LIGO-T040004-04-D

ADVANCED LIGO

Review of GEO 600 Blade Eddy Current Damper

R.Jones, C.Torrie

Figure (iv): - Close up of the end of the damper arm with the copper sleeve locating via a threaded rod.

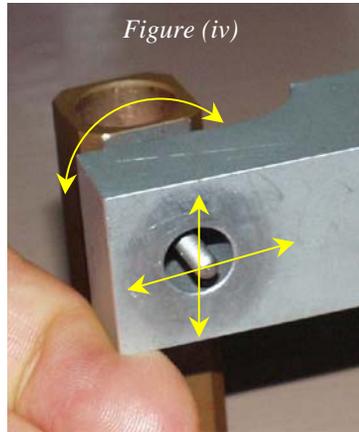
- Increase the range of adjustability of the copper with respect to the Damper Arm, following the last point
(Action: suitably increase diameter of 10mm clear hole in the damper arm)

Figure (v): The experimental setup
(a) Overview, and (b) Close-up of copper sleeve (D030263)

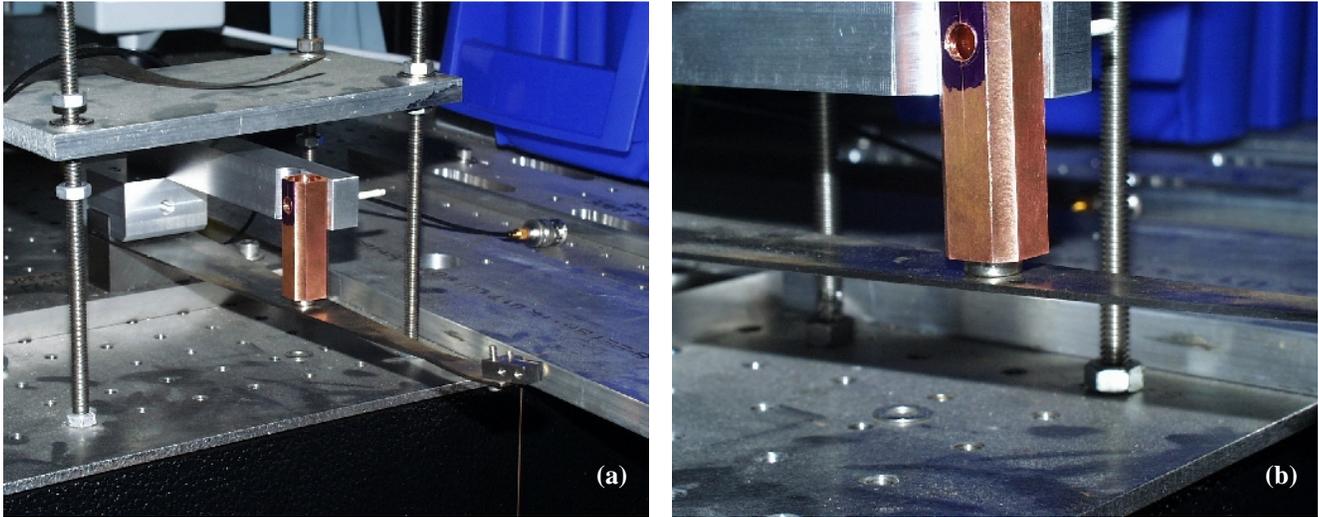
- Assembly was tight fit onto top of the MC blade clamp
(Action: increase diameter of counter bores for cap screws)
- There is an insufficient gap between the 'jaw' (D030262_Clamp_Lshape) of the Damper and the top surface of the MC blade
(Action: remove some material from D030262 to account for this)

- There is no design for magnet/spacer that is mounted on the blade
(Action: consider with reference to the following comment)
- There are no holes in the blades for attaching the magnet/spacer
(Action: discuss the need to rework MC blades? Check RM upper blade design)

- Introduce continuity probe to test alignment of copper/magnet during assembly – this will require the copper sleeve to be isolated from the remainder of the ECD assembly
(Action: introduce 'PFA 440HP' Teflon shoulder/sleeve)
